RE: **Lot 8 Block 8 Volcano Cliffs Unit 18 SAD 228**  
**6400 Canavio Rd. NW**  
**Grading and Drainage Plan**  
**Engineers Stamp Date 3/11/19 (D10D003E8)**  
**Pad Certification Date 7/2/19**

Based upon the information provided in your submittal received 7/2/19, this plan is approved for Building Permit.

## DRAINAGE AND TRANSPORTATION INFORMATION SHEET (REV 6/2018)

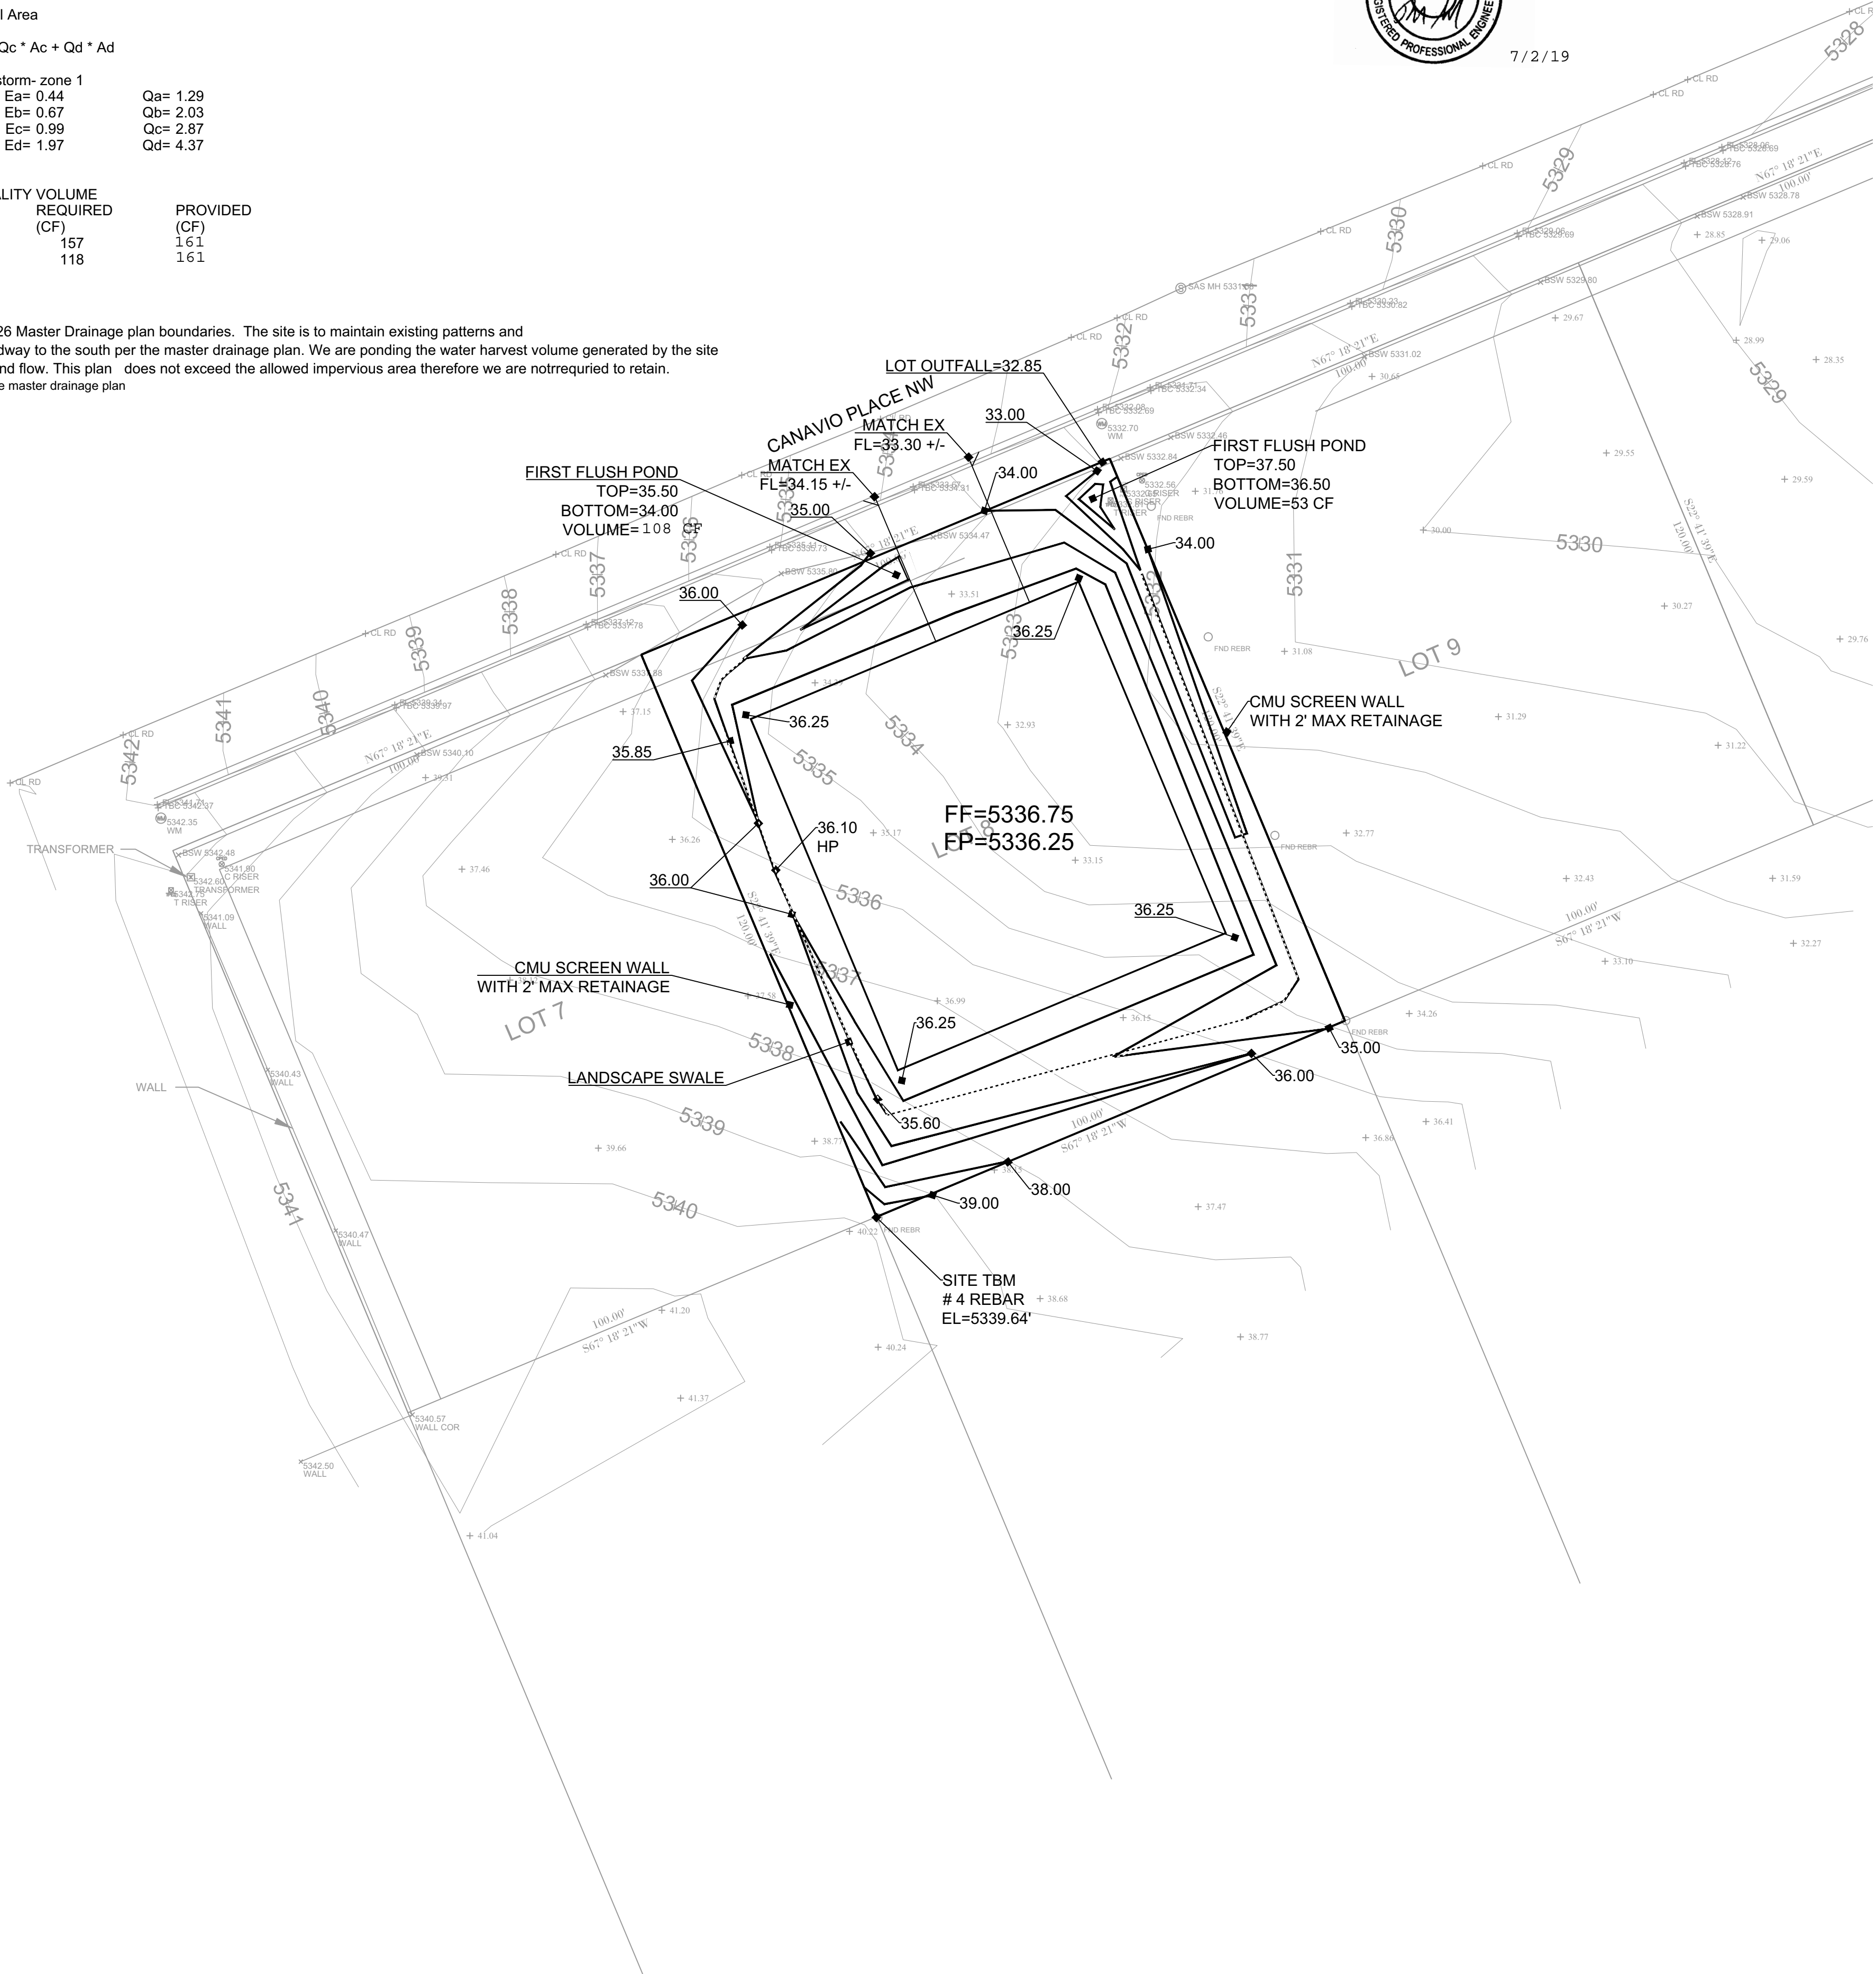
**Reiterate to the Owner/Contractor that a separate permit for a garden/retaining wall must be obtained, with the approved G&D plan dated 3/11/19 and Pad Certification Date 7/2/19.**

Prior to Certificate of Occupancy release, Engineer Certification per the DPM checklist of this plan will be required.
